### TO THE BID DOCUMENTS FOR WAIHEE WELLS ELECTRICAL UPGRADES DWS JOB NO. 19-01-G

**ADDENDUM NO. 1  
TO THE BID DOCUMENTS FOR  
WAIHEE WELLS ELECTRICAL UPGRADES  
DWS JOB NO. 19-01-G**

Date: September 20, 2019

**E-3**

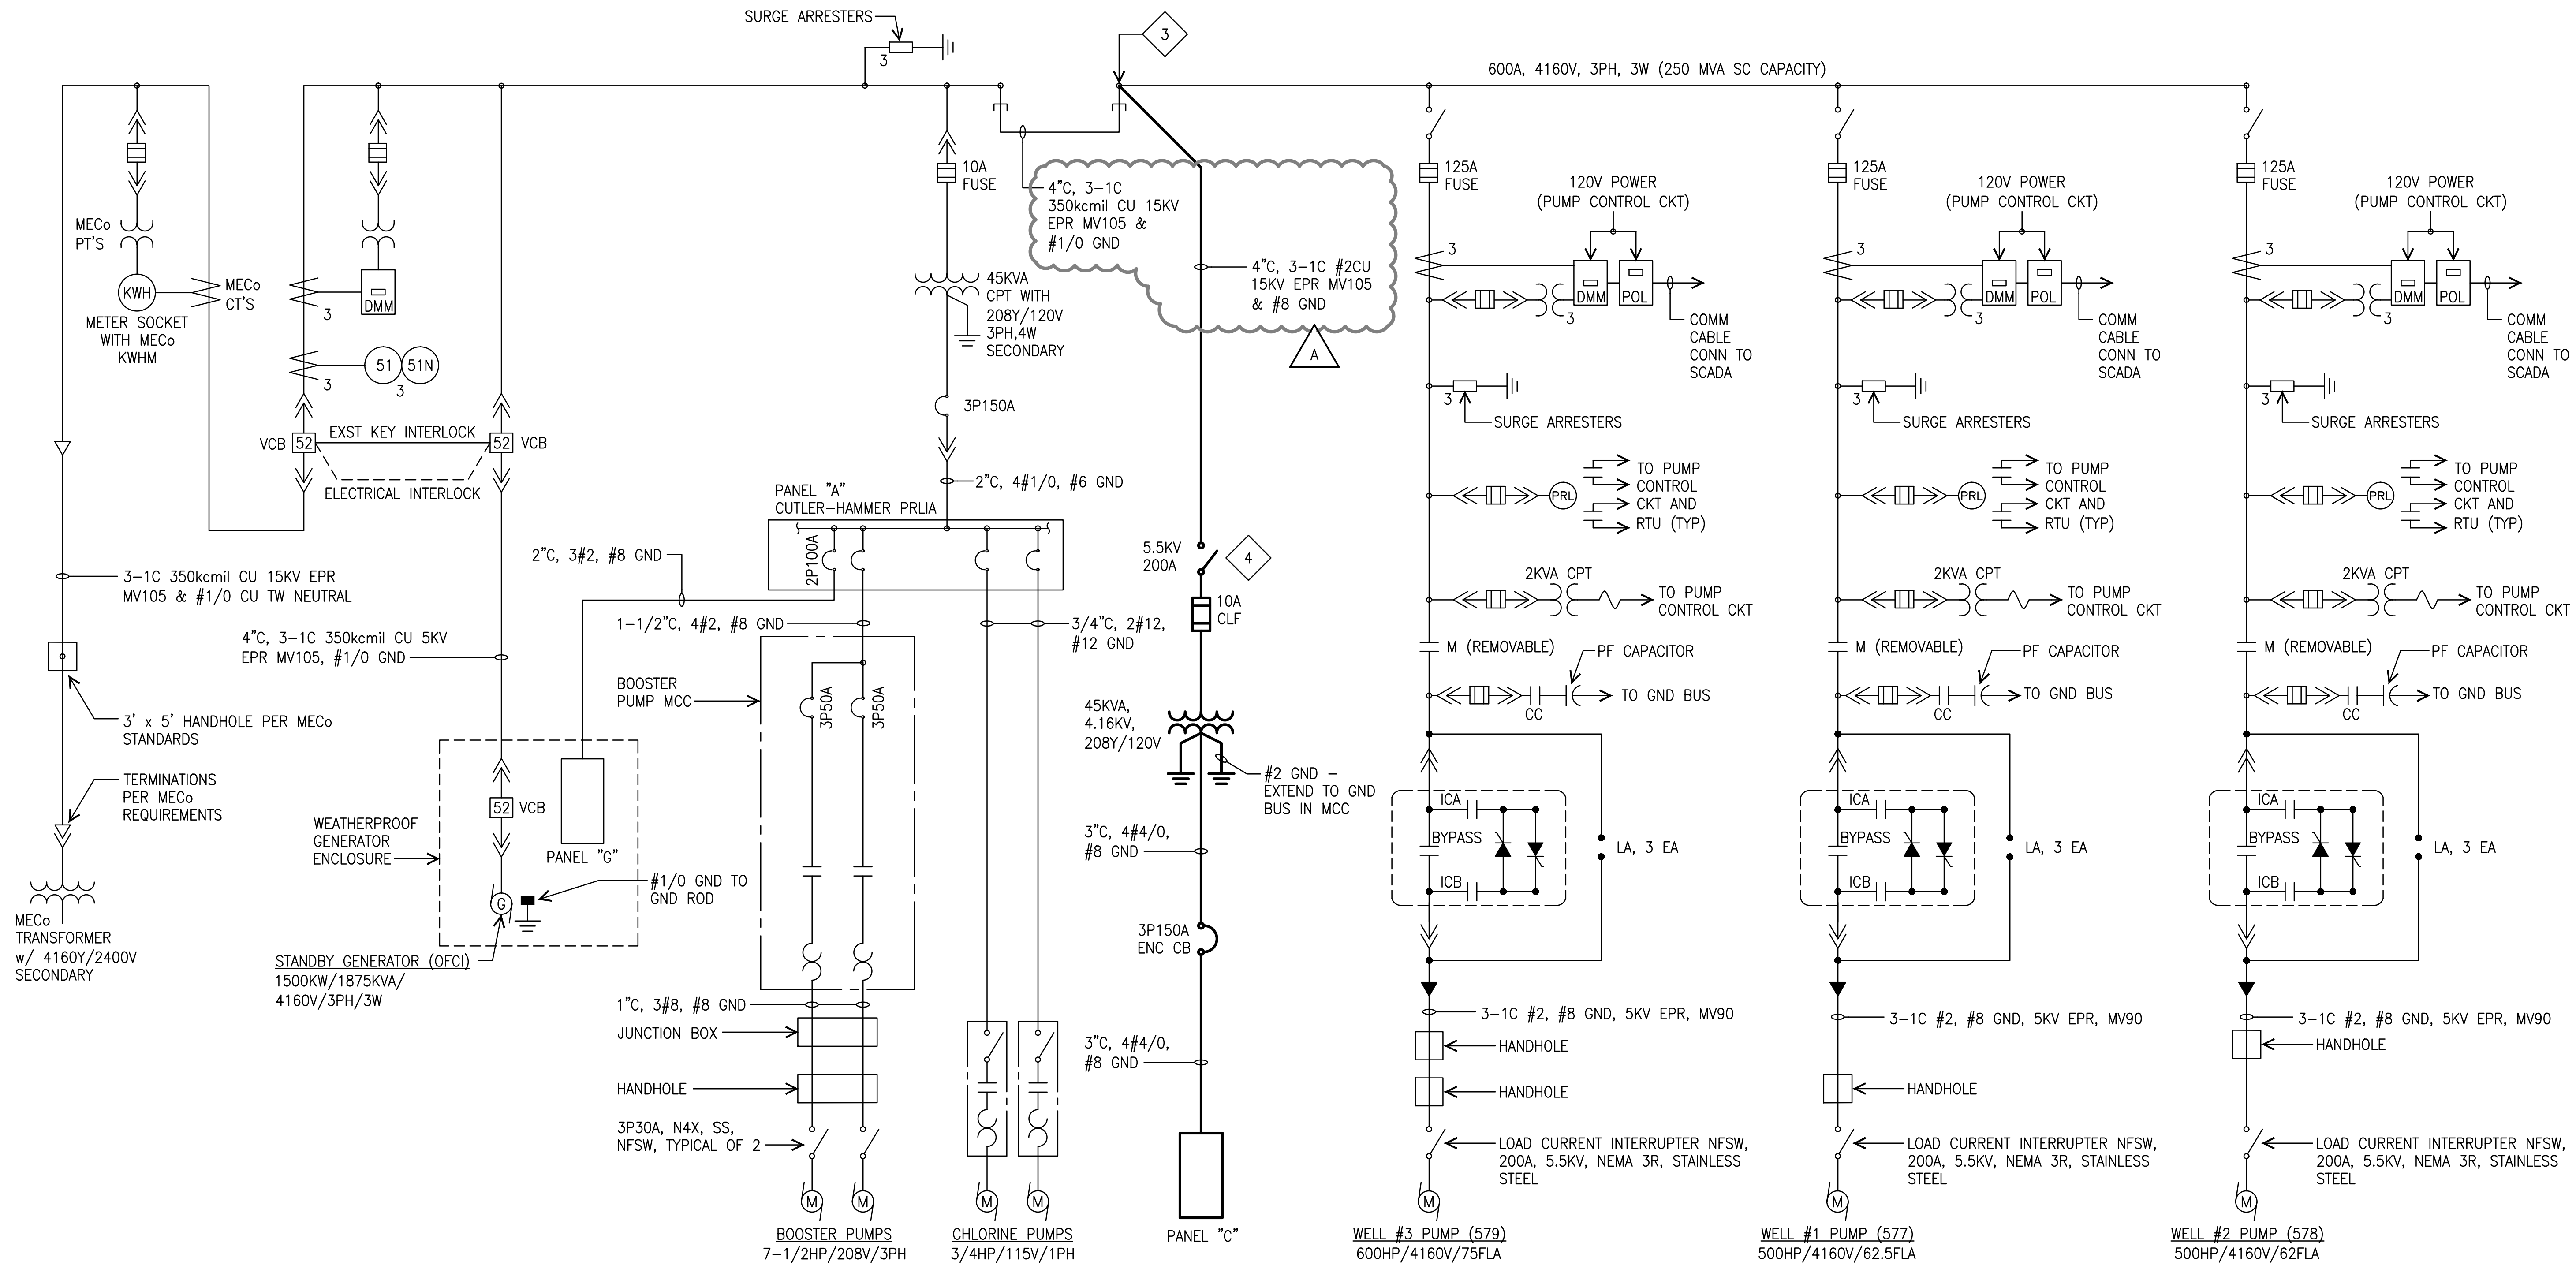
1. Sheet E-3 – One Line Diagram: Sheet E-3 shall be deleted and replaced. Revised drawing with the changes discussed is attached. The tap conductors for the transformer primary circuit between the MCC tap point and the line side of the fused switch shall be 3-1C#2 CU, 15 KV EPR MV105 & #8G instead of 3-1C 350kcmil.
